Tusuka Stitches Ltd.

10th October 2021

Buildings Information

2nd floor layout plan

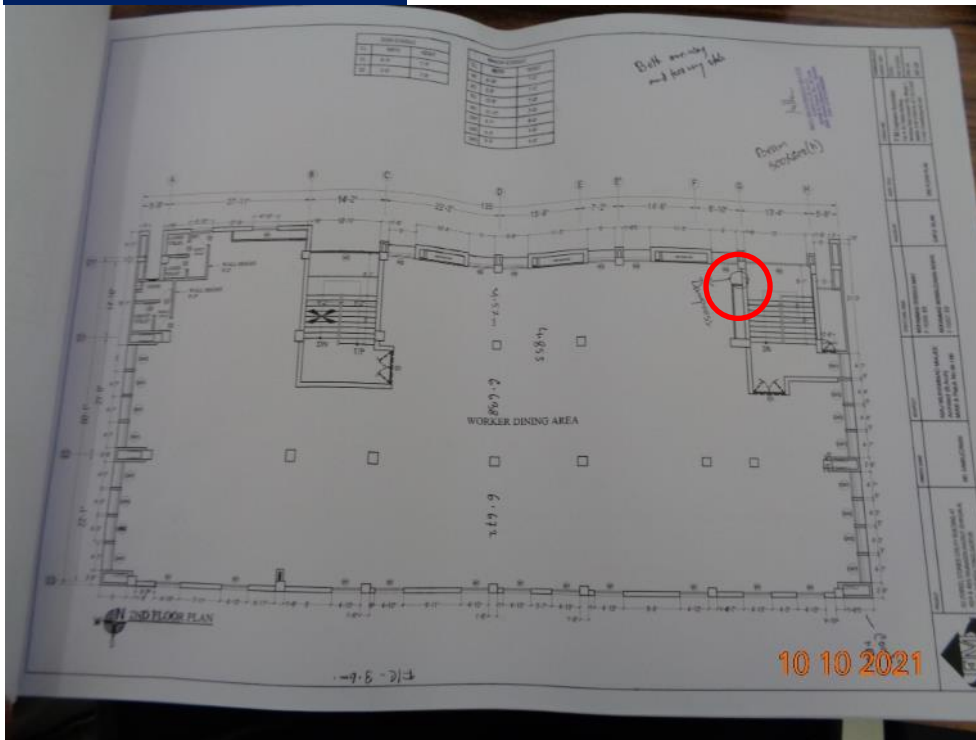
Signage of dampness

Signage of dampness observed in the building. Building engineer is required to identify the reason of the dampness and suggest suitable repair works.
